STAFF RECOMMENDATION

1209 Elmwood Avenue

February 17, 2021

Application: New Construction—Addition and Outbuilding; Partial Demolition

Figure 1. 1209 Elmwood Avenue, February 2021.

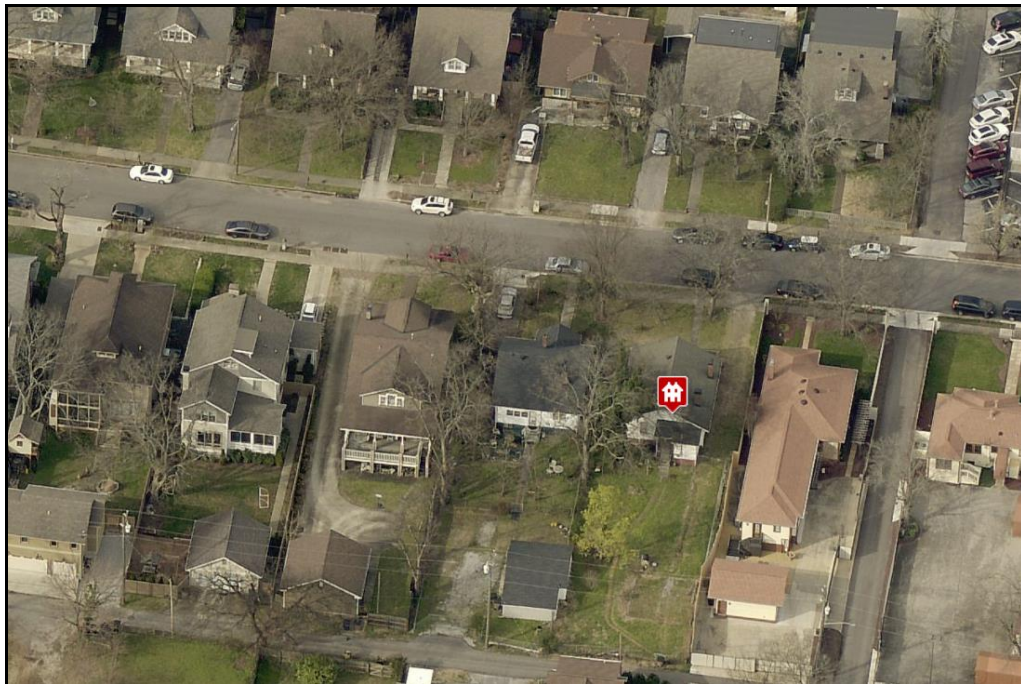
Background: The house located at 1209 Elmwood Avenue is a c. 1920 bungalow that contributes to the historic character of the Belmont-Hillsboro neighborhood (Figure 1).

Figure 3. Proposed left-side elevation with outline of existing house.

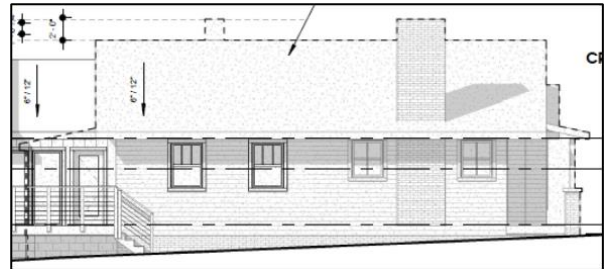
Demolition: The application includes the removal of an existing single-story shed roof piece and the removal of paired windows and a shorter double hung window on the left-side façade at the ~~at~~ and beyond the midpoint (Figure 2). Staff finds that removal of these windows can be appropriate given their location at and beyond the midpoint. The applicant proposes to add two double-hung windows so that there is not a large expanse of wall without a window or door opening (Figure 3).

For these reasons, staff finds that the proposed partial demolition does not meet Section V.1 for inappropriate demolition and can meet Section V.2 for appropriate demolition.

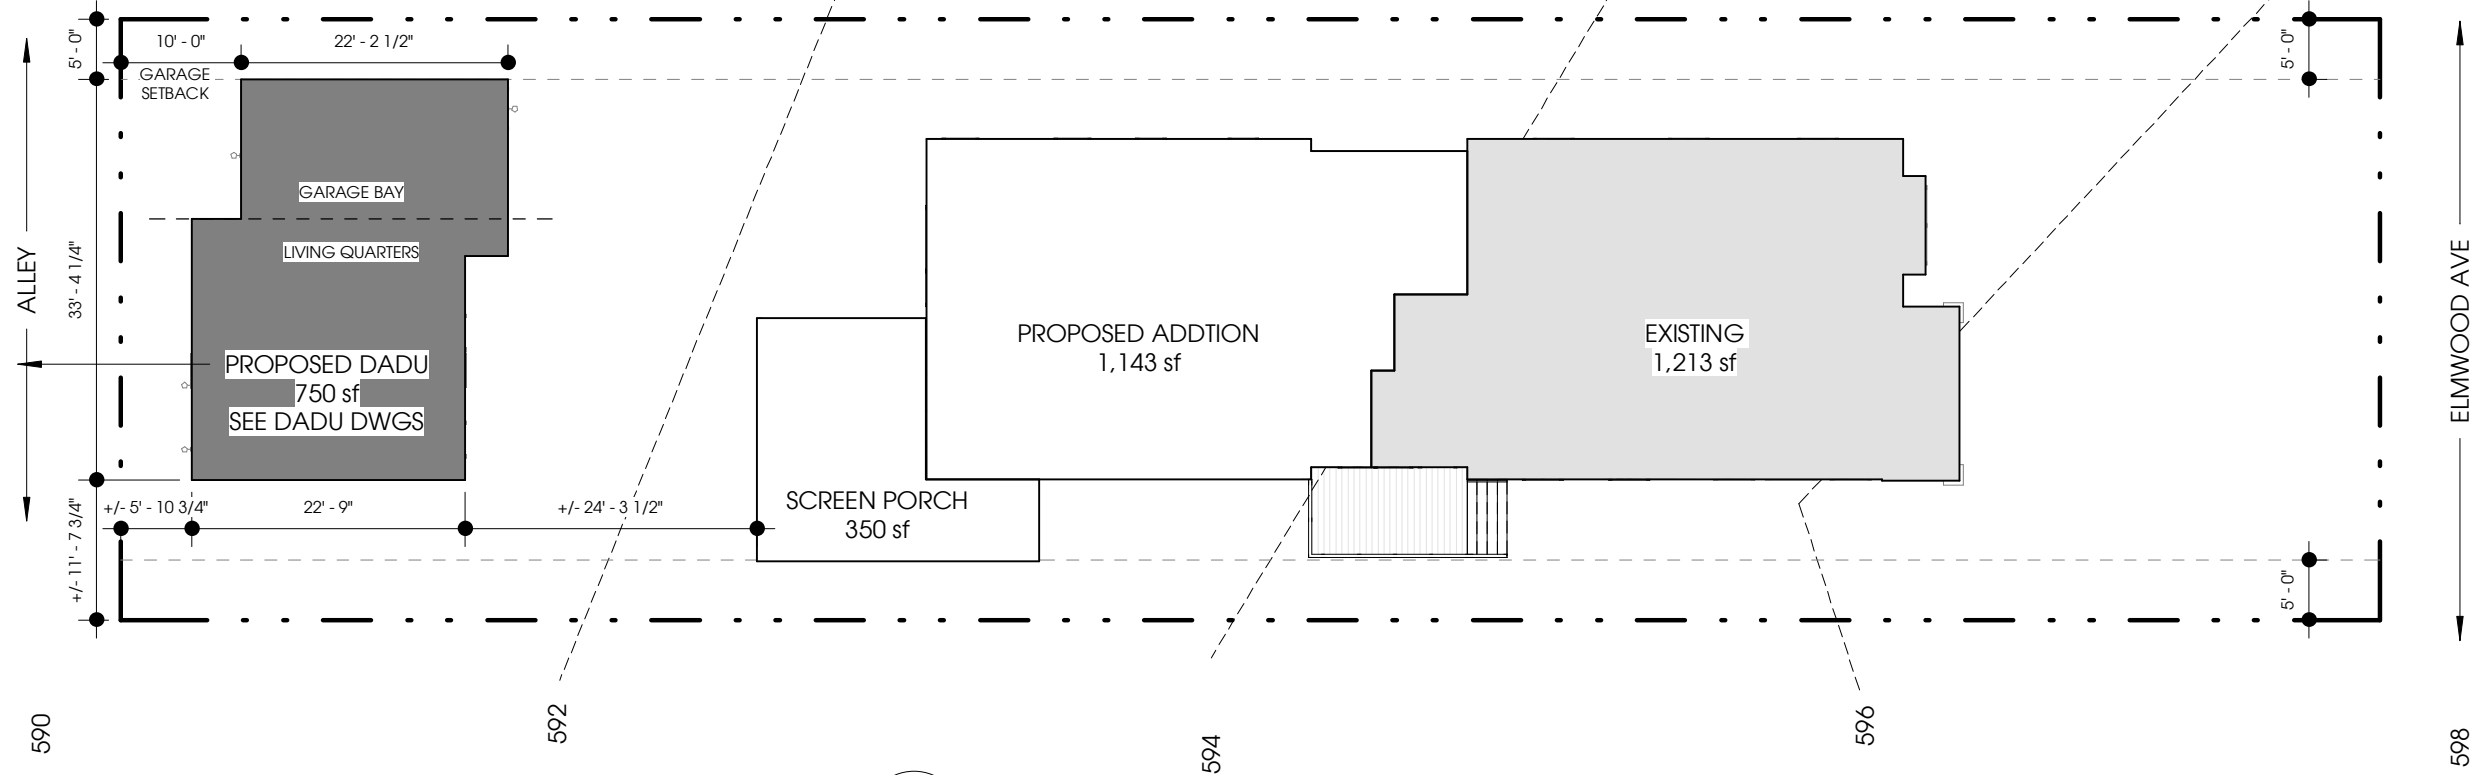
MINIMUM	PROPOSED OUTBUILDING
Building located towards rear	-	Yes

of lot		
Space between principal building and garage	20'	24'-3"
Rear setback – garage doors face alley	5'	5'-10"
Right side setback	5'	5'
Left side setback	5'	11'-8"
How is the building accessed?	-	From alley
Two different doors rather than one large door (if street facing)?	-	N/A

The proposed setbacks for the DADU meet the design guidelines.
